TOWN OF APPLE VALLEY

SITE PLAN REVIEW 2015-001

MITIGATED NEGATIVE DECLARATION (SCH #2016041058)

RESPONSE TO COMMENTS

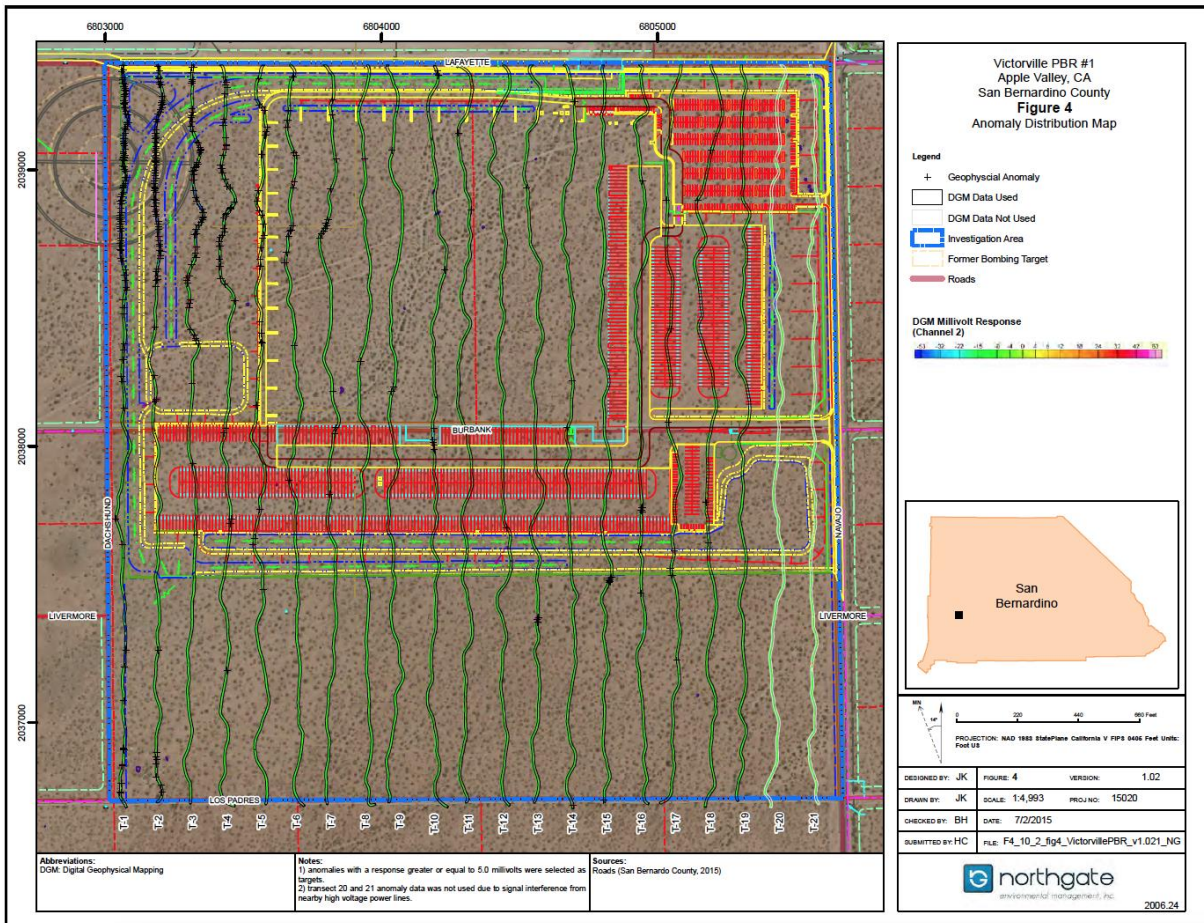
1. Section VII, Hazards and Hazardous Materials - This section of the IS/MND describes a portion of the Project site as being part of a larger area formerly used as a practice bombing range for military training purposes during the 1940's. The boundaries of the former bombing range were not delineated in the IS/MND, rather the location was roughly identified as the northwest corner of the site.

A review of the Water Board's GeoTracker database indicates that the Project site was part of a larger "Formerly Used Defense Site" (FUDS) subject to cleanup requirements under the oversight of the California Department of Toxic Substances Control (DTSC [Site ID.No. 80000405]). This is consistent with the reported former land uses

described in the IS/MND. Based on the information provided in the NOI, it does not appear that DTSC was provided a copy of the IS/MND for review and comment. We request that the lead agency consult with and request comments from DTSC with respect to the proposed development of this site.

Response A-2 The location of the site is clearly identified in the referenced Ordnance Report, and correctly described in the IS/MND. A reproduction of Figure 4 of the Ordnance Report is provided below.
